Parker Hannifin Corporation

SERVICE BULLETIN

MAIN BRAKE ASSEMBLY 30-204A – TORQUE RING – INSPECT/REPLACE

Figure 1

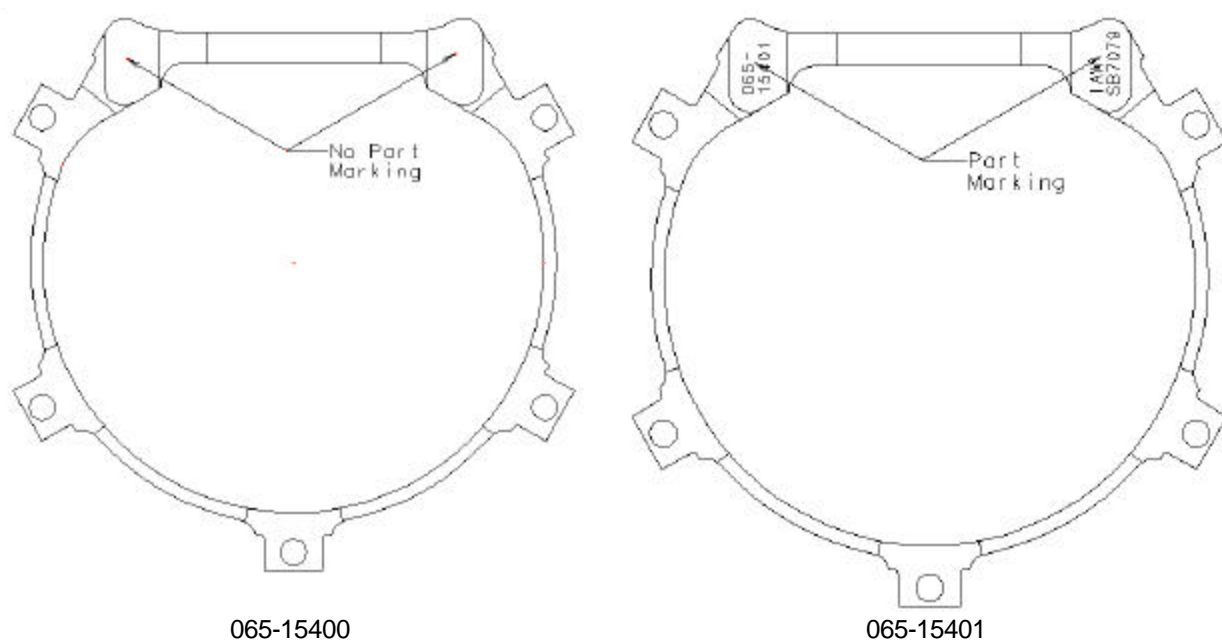
- REASON:** Raytheon Aircraft Co. (RAC) Service Bulletin 32-3576 introduced main landing gear (MLG) socket, RAC P/N 129-810022-0003. RAC P/N 129-810022-0003 interferes with Parker Hannifin P/N 065-15400. P/N 065-15400 is a component of Parker Hannifin Brake Assembly 30-204A that was used on Brake serial numbers 101 thru 872. Beginning with S/N 873, 30-204A Brake Assemblies are assembled with P/N 065-15401 when new.

- 1) At the time of installation of MLG socket RAC P/N 129-810022-0003, or at next brake overhaul whichever occurs first, inspect aircraft records to determine if Main Wheel and Brake Assembly Conversion Kit P/Ns 199-184, 199-220, or 199-220A are installed.
- 2) Aircraft that have been identified as not being equipped with Conversion Kit P/Ns 199-184, 199-220, or 199-220A may be returned to service.
- 3) For aircraft that are identified as being equipped with the 199-184, 199-220, or 199-220A Wheel and Brake Kit, inspect the Brake Assembly to determine which torque ring part number is installed (ref. Figure 1).

- 4) If inspection indicates that the 065-15400 torque ring is installed, contact Parker Hannifin, Aircraft Wheel & Brake Division Service Center (Ph. 1-440-937-1272) for instructions to obtain replacement 065-15401 torque rings.
- 5) Consult CM 30-204A for disassembly and assembly instructions as required. Re-assemble with P/N 065-15401 in lieu of 065-15400. Note that P/N 065-15401 is marked to indicate that the assembly has been reworked in accordance with (IAW) Service Bulletin SB7079.
- 6) Aircraft with 30-204A main brake assemblies, reworked to use Parker P/N 065-15401 torque rings, may be returned to service.
